BID # 02-220518

DISTRICT WIDE SEAL & STRIPE PROJECT – EAST SIDE
VICTOR ELEMENTARY SCHOOL DISTRICT
VICTORVILLE, CA

May 13th, 2022

ADDENDUM – 02

LOMITAS ELEMENTARY SCHOOL Total Capacity: 1,075

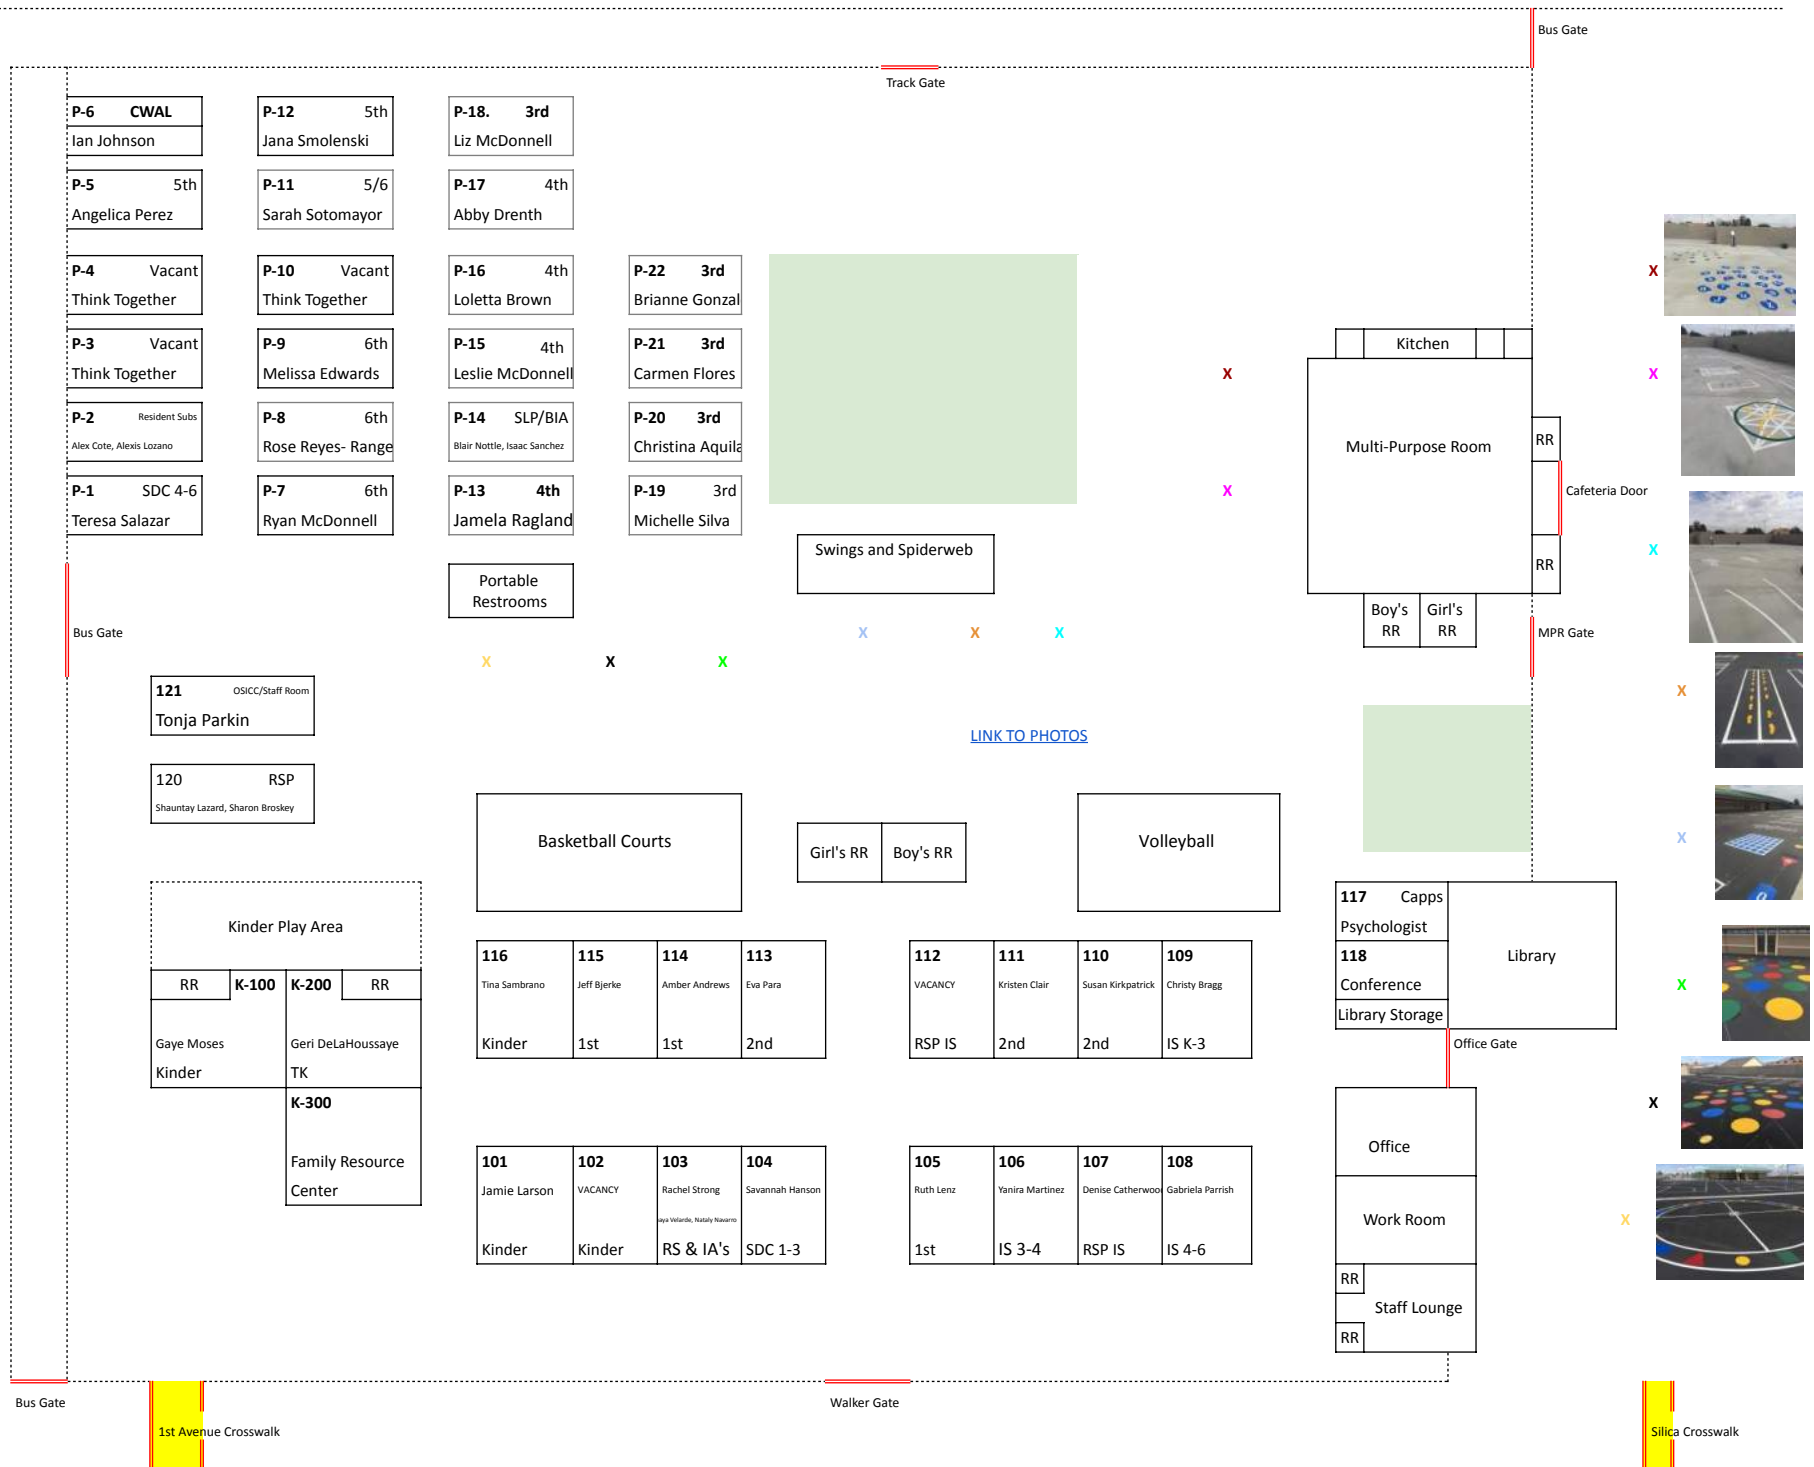
Special Conditions
 1. Contractor to provide additional striping as shown per Sheet L-1.

SHEET L-1: STRIPING PLAN

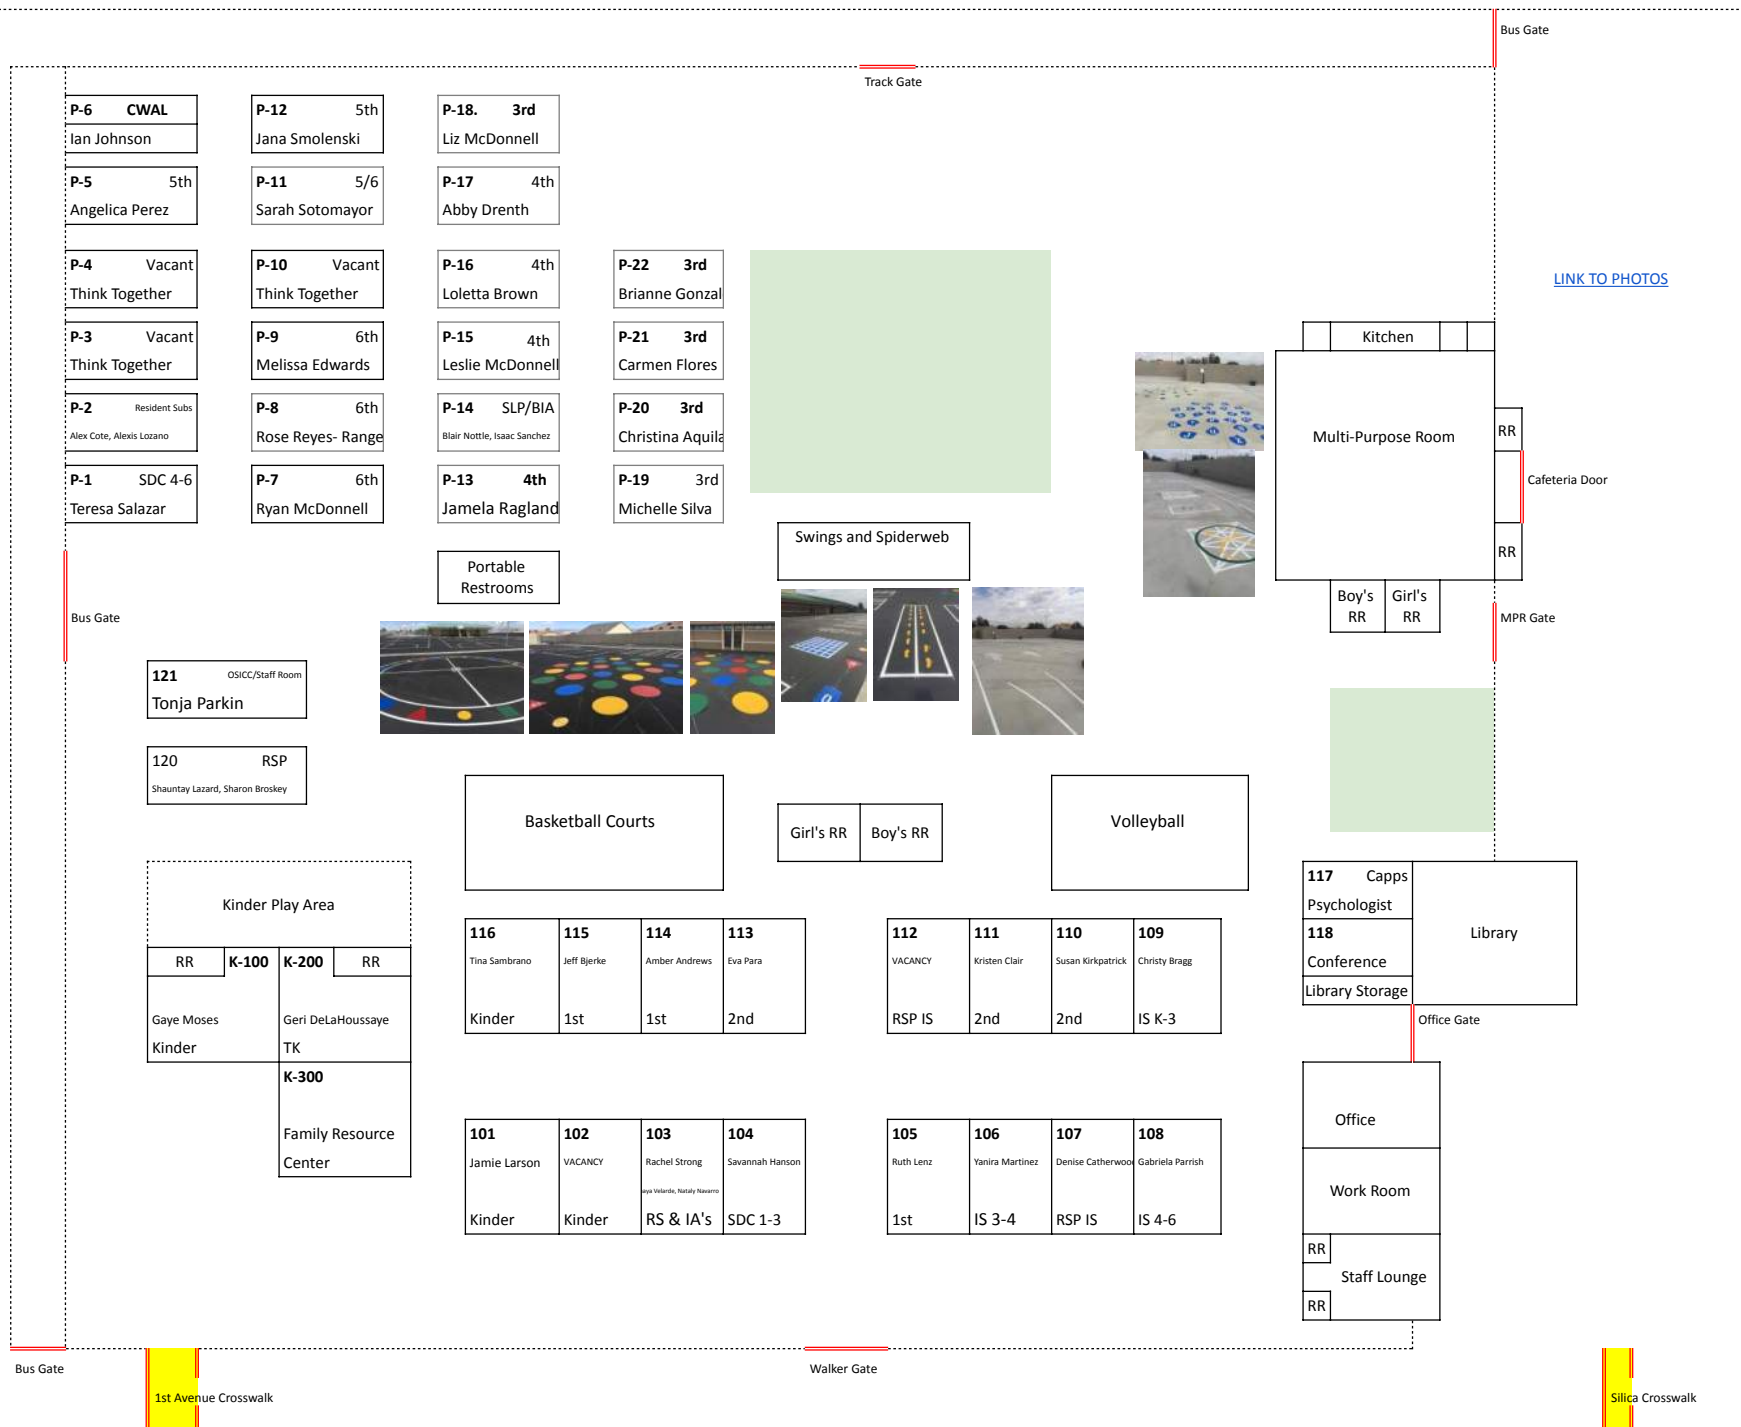
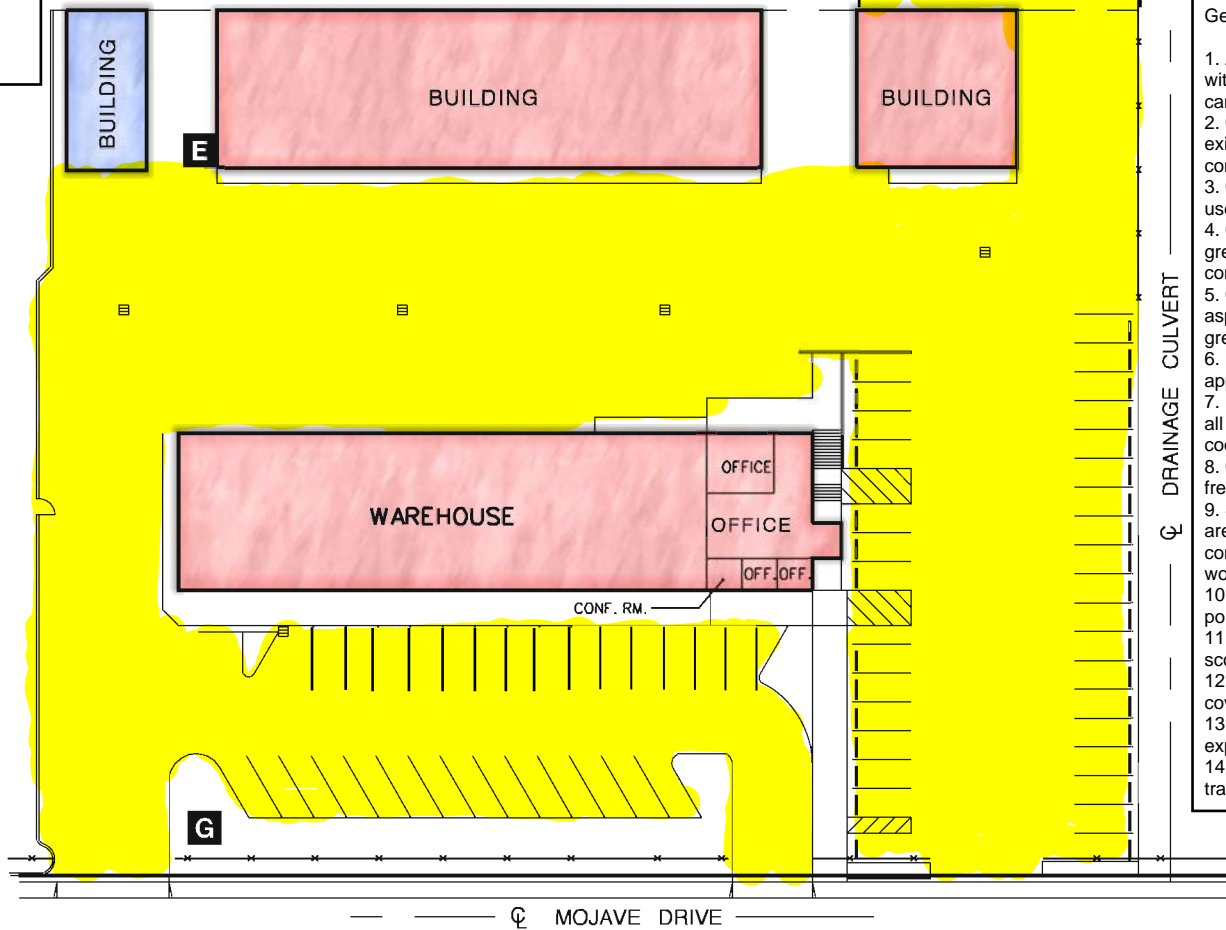
- D. Add Sheet G-1 to include additional striping required at Galileo Academy.
- E. Add Sheet L-1 to include additional striping required at Lomitas.
- F. Add Sheet GT-1 to include additional striping required at Green Tree East Leadership Academy.

MOJAVE VISTA ELEMENTARY SCHOOL

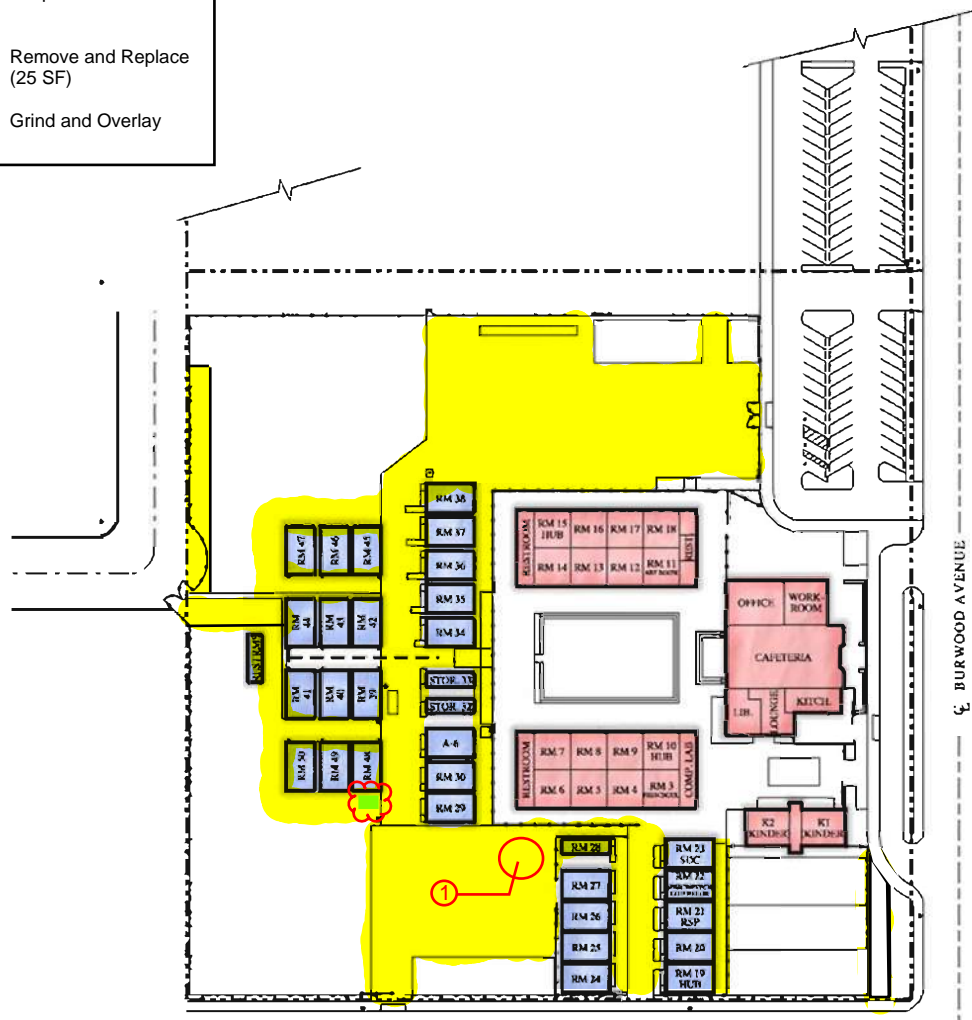
- Special Conditions
1. Existing striping for "blob" shape to be replaced with circle.

SHEET G-1 - ADDITIONAL STRIPING PLAN

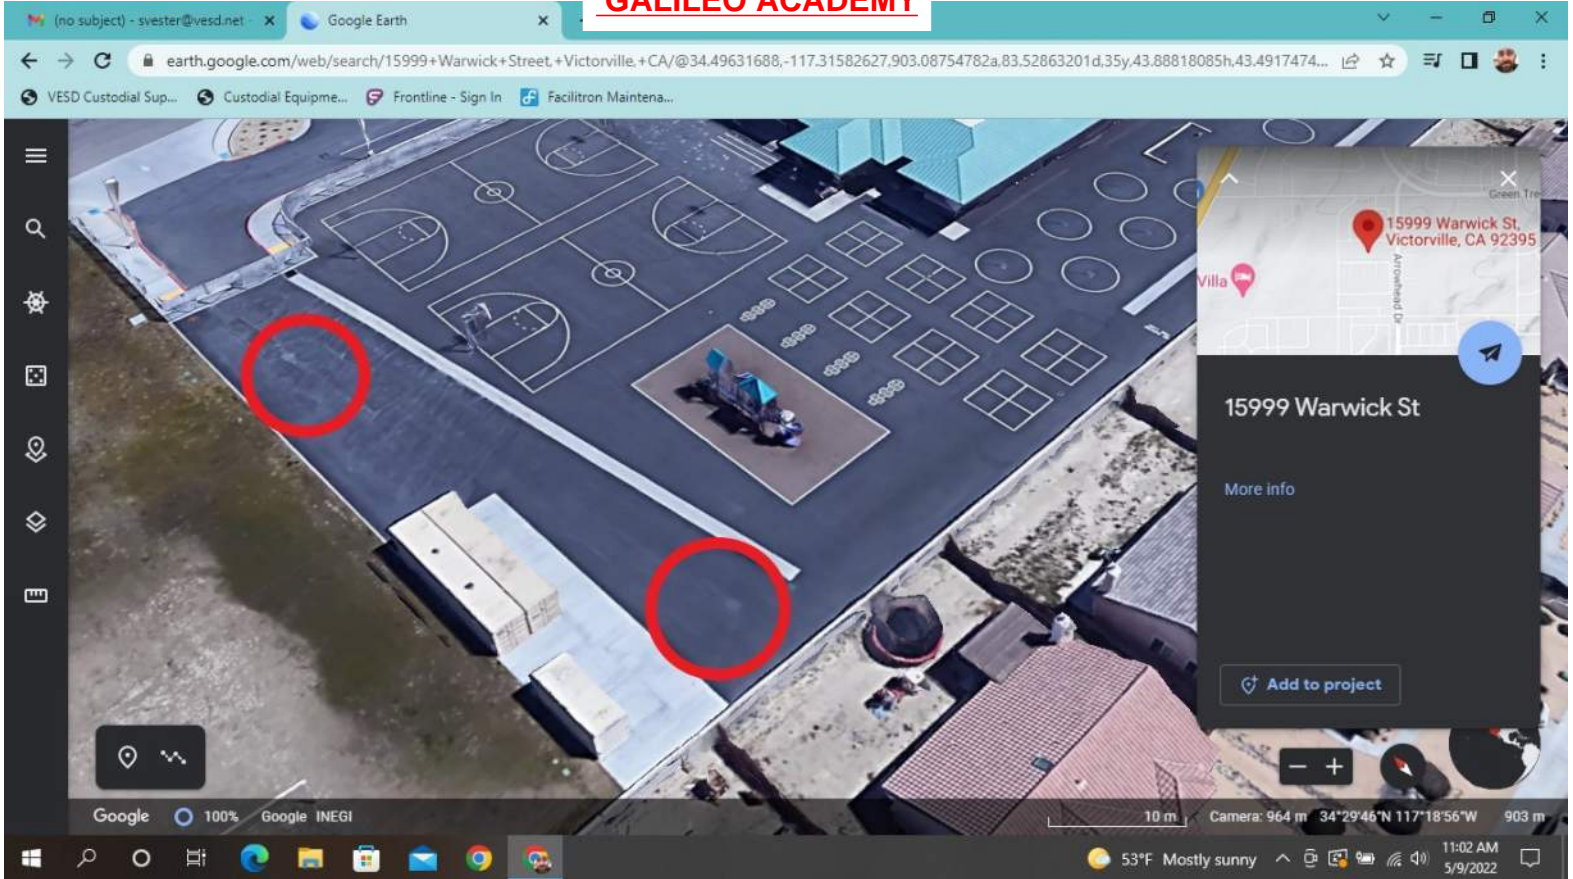
1. Contractor to include additional striping as shown on Sheet G-1 - Additional Striping Plan.

SHEET T-1: BUS STALL NUMBERING SCHEME

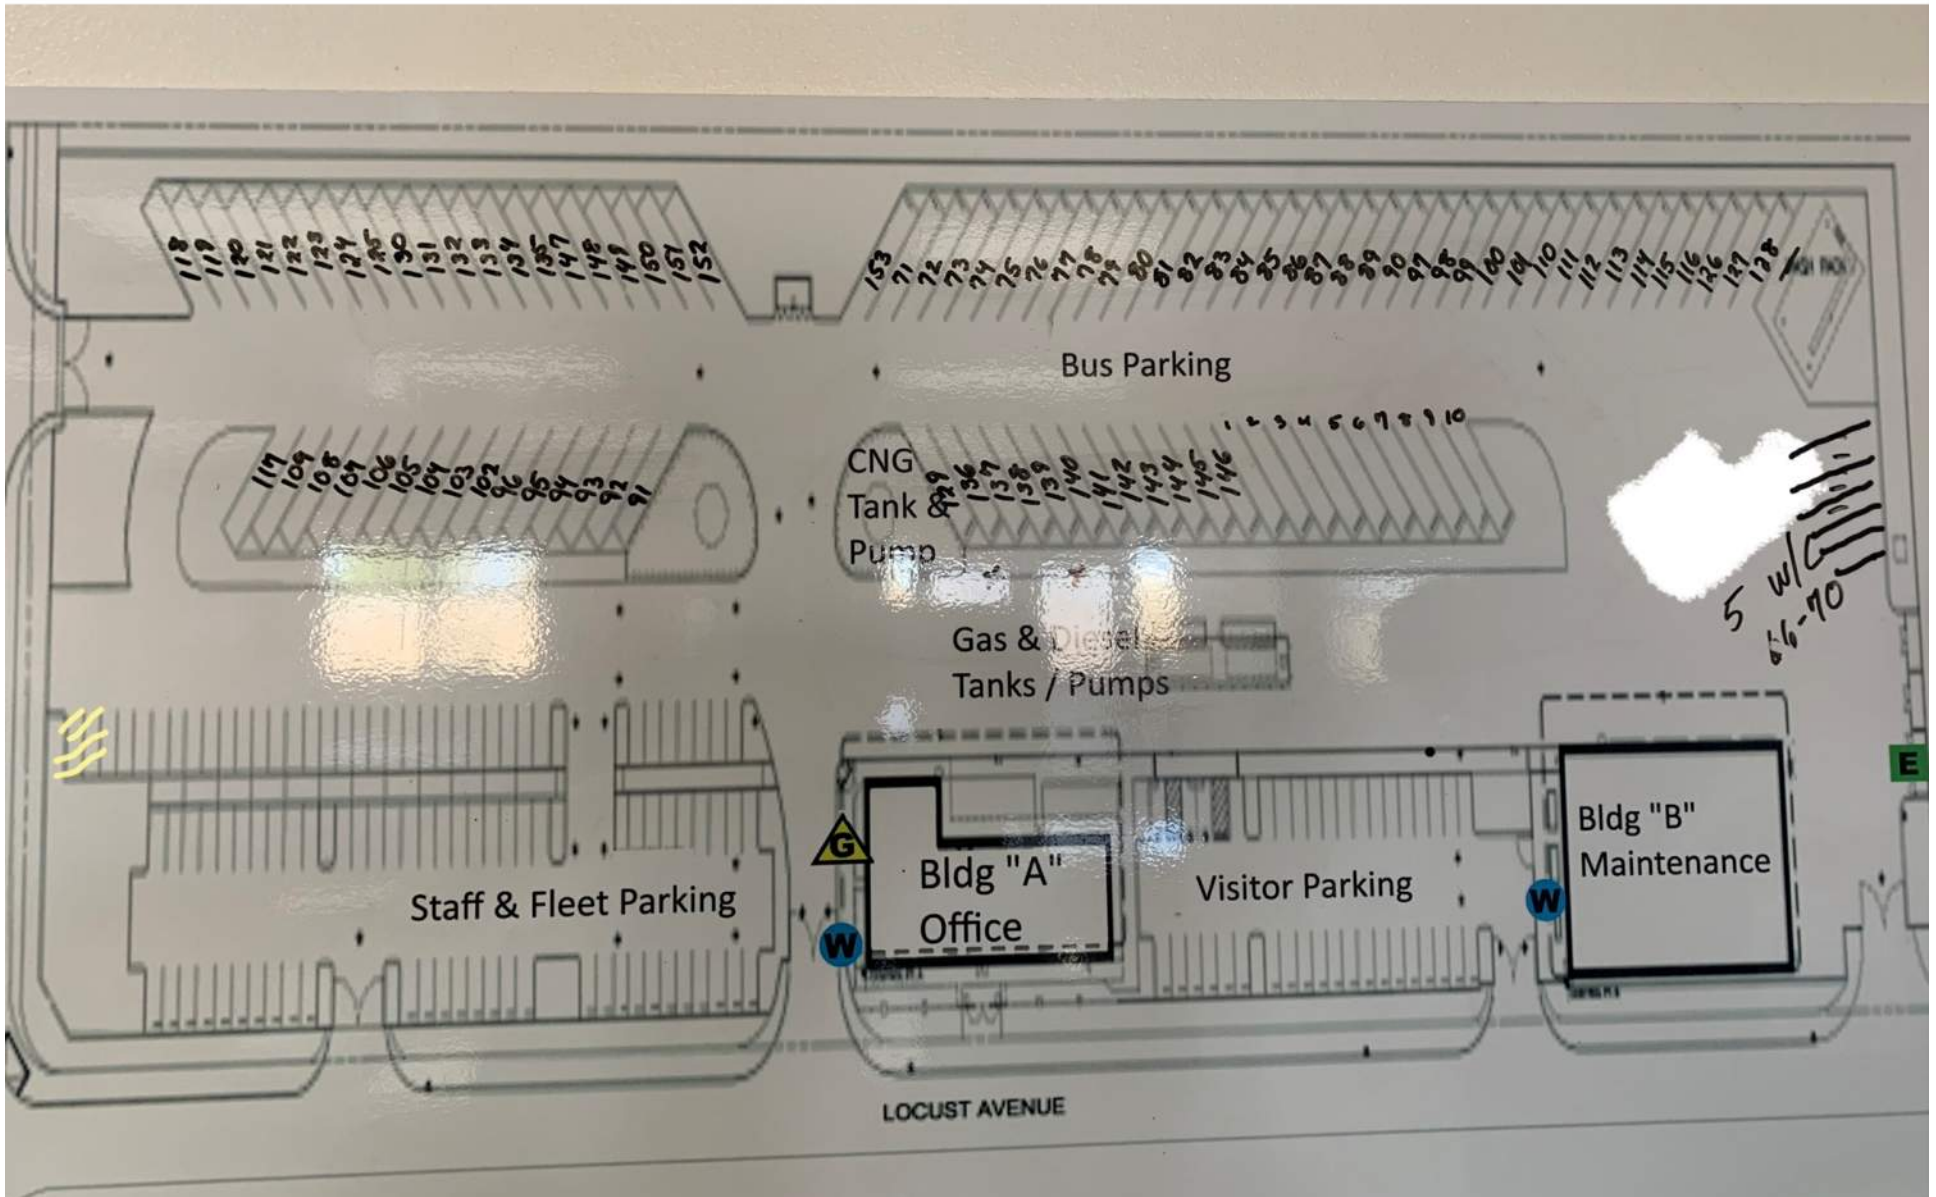
- G. Add Sheet T-1 to include new numbering scheme required at VESD Transportation.
- ITEM NO. 3 PROJECT MANUAL, CONTRACT REQUIREMENTS – PROJECT SCHEDULE

1. Contractor to stripe Bus Stalls per revised numbering scheme shown on Sheet T-1.
2. Existing striping to be modified to exclude last two parking stalls, contractor to hatch out area.
